ALNRC 00025
May 15, 2009

Enclosure B

Red-line strikeout changes to Sections ~~2.5~~⁴, 4.1, 4.2 and 4.3 of the ER

Figure 4.3-4—Waters of the U.S. Impacts (Sheet 1)

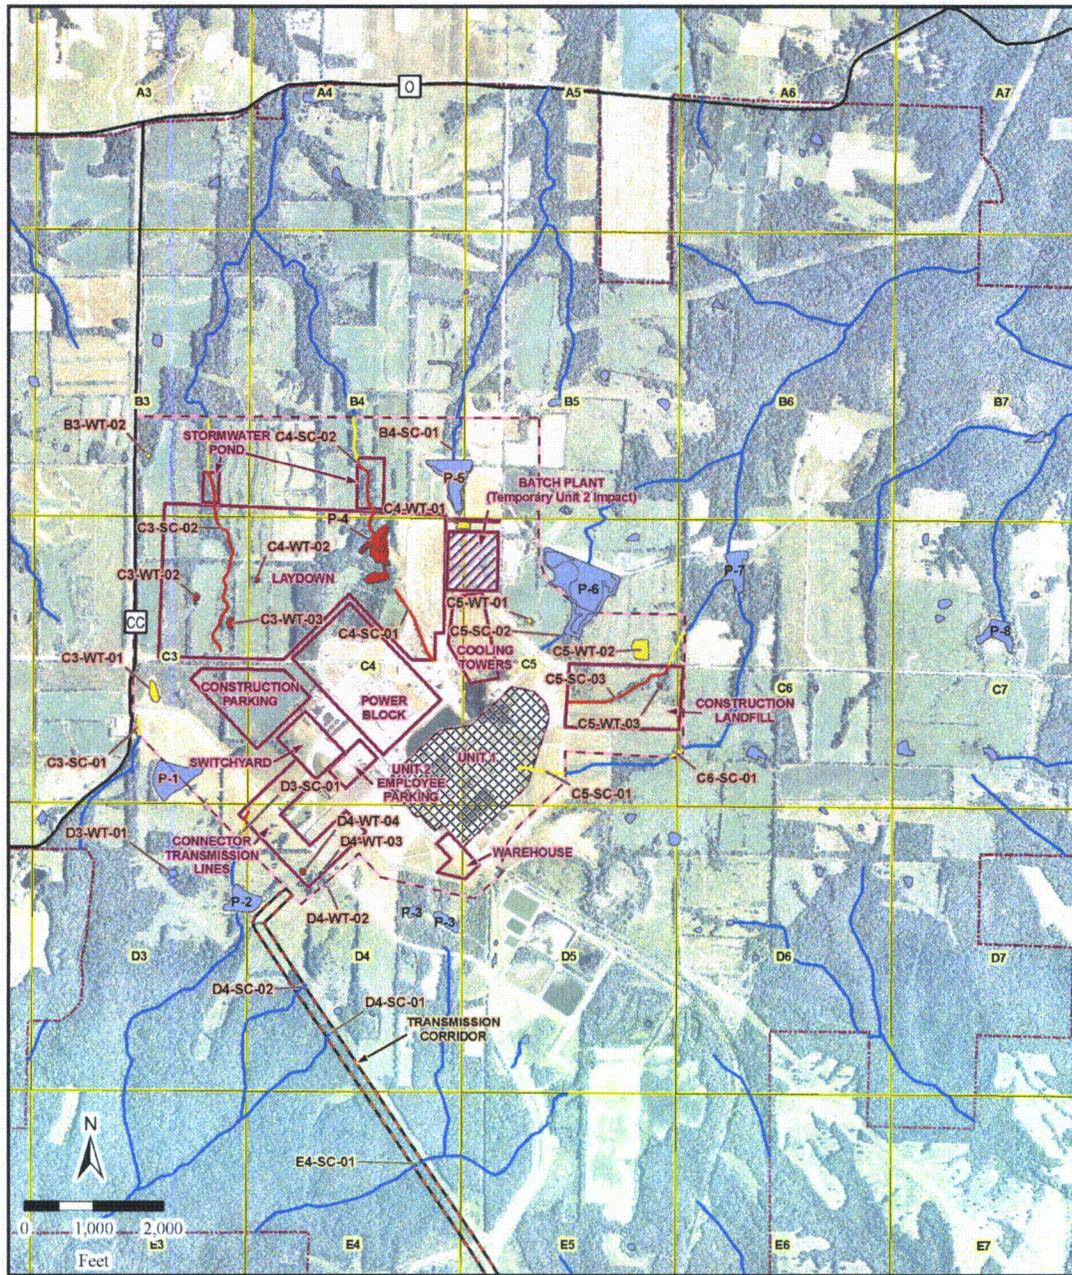
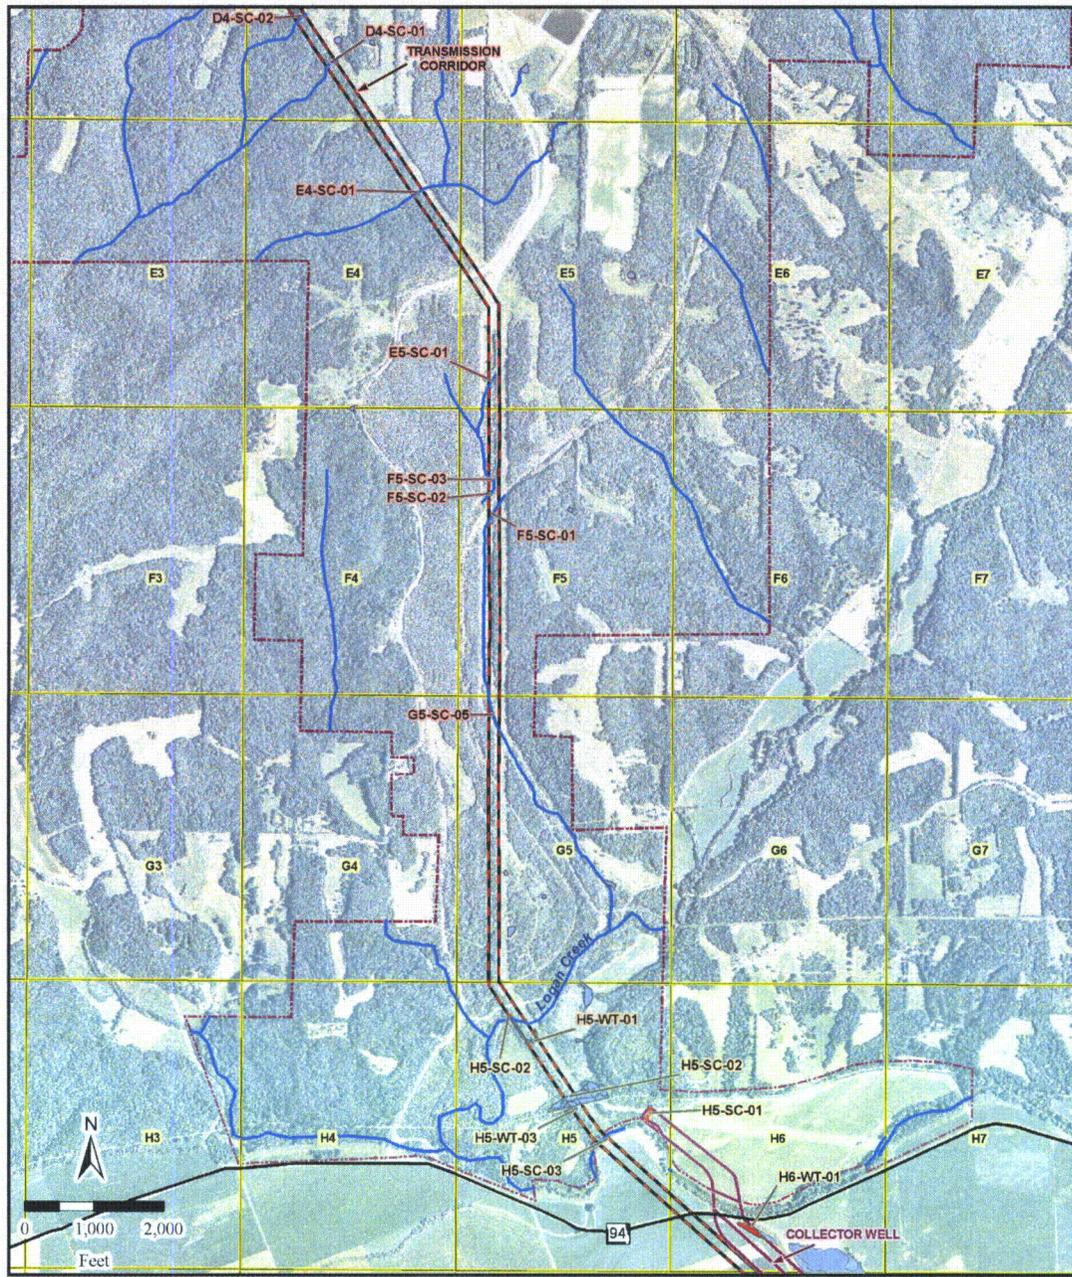
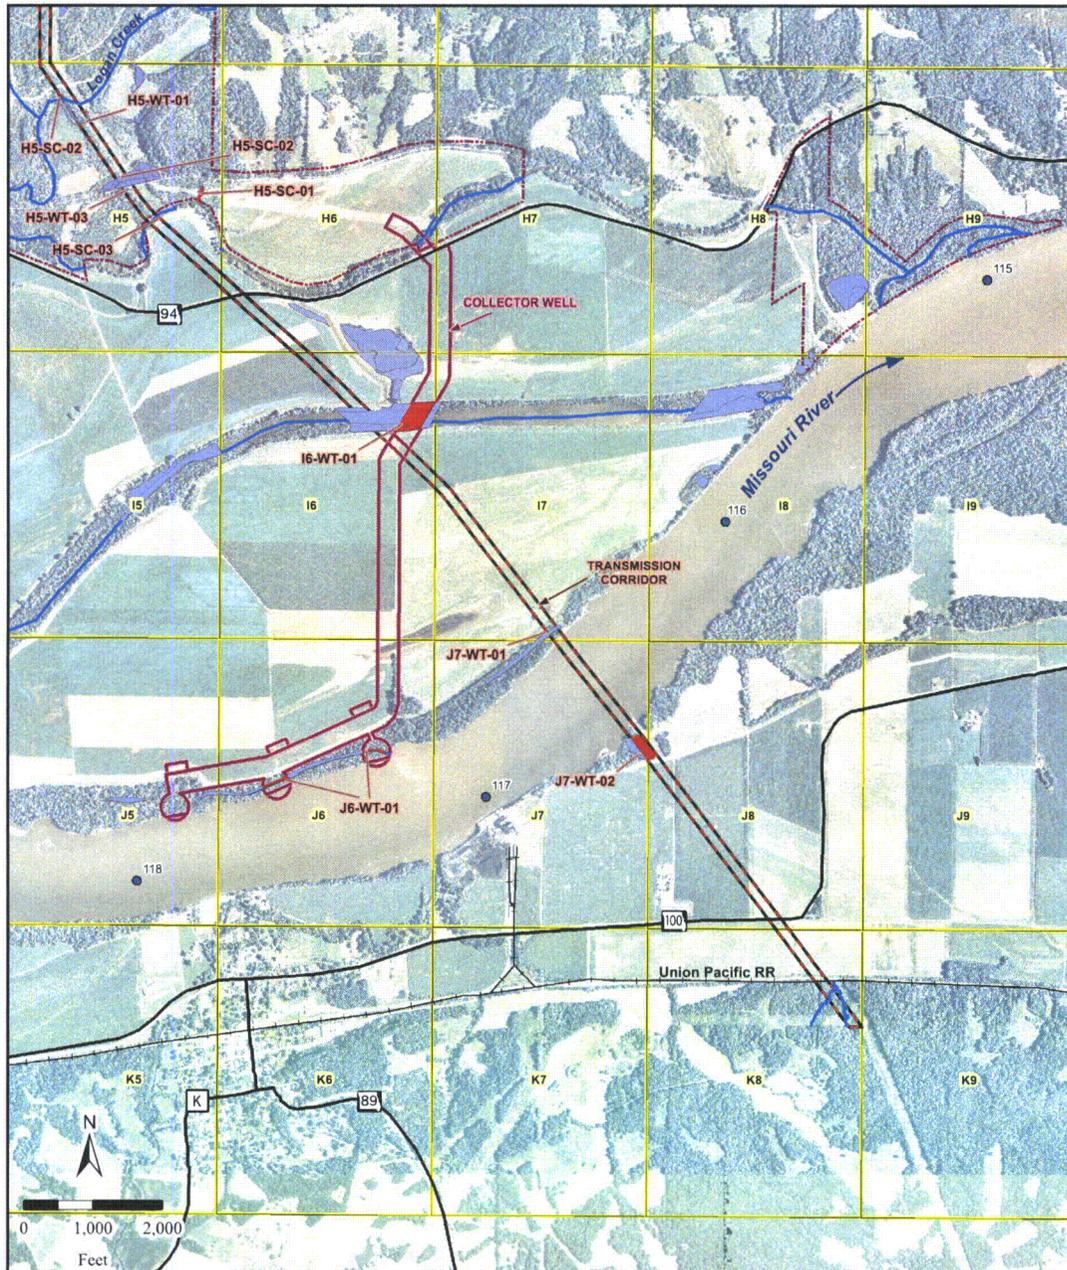
~~Figure 4.3-4 through Figure 4.3-6~~ Table 4.3-1 provides a breakdown by land use designation of the areas potentially impacted by Callaway Plant Unit 2 construction. Permanent and temporary impacts are listed separately on ~~Figure 4.3-4 through Figure 4.3-6~~ Table 4.3-1.

Construction activities would result in the permanent loss, through filling, of wetland habitat and wetland buffer. Section 4.3.1.3 provides a detailed discussion of construction impacts to wetlands. Figure 4.3-4 through Figure 4.3-6 Table 4.3-2 and Table 4.3-3 includes a summary summaries of wetland and wetland buffers potentially impacted by Callaway Plant Unit 2 construction.

- ◆ Reducing the available infiltration area;
- ◆ Grading and the subsequent covering of the 50 acre (20.2 hectare) Callaway Plant Unit 2 power block foundation (refer to ~~Figure 4.3-4 through Figure 4.3-6~~ Table 4.1-1 for construction areas acreage);

In accordance with ~~Figure 4.3-4 through Figure 4.3-6~~ ~~Table 4.3-1~~ a total of ~~55.5-58.0 acres (22.5-23.5 hectares)~~ of impacts are considered temporary. Approximately 14 acres (6 hectares) of impacts will be considered temporary impacts associated with material storage and concrete batch plant. This area is already located within developed areas of the AmerenUE property and thus would not affect natural communities at the site. An additional 41.5 acres (16.8 hectares) of impacts will be considered temporary impacts associated with construction of the new overhead transmission line facility. Approximately 16 acres (6.5 hectares) of the temporary impacts will occur within developed areas of the site and will not affect natural terrestrial ecosystems. Impacts to terrestrial ecosystems and wetlands are summarized in ~~Figure 4.3-4 through Figure 4.3-6~~ ~~Table 4.3-1~~ and ~~Figure 4.3-4 through Figure 4.3-6~~ ~~Table 4.3-2~~, respectively.
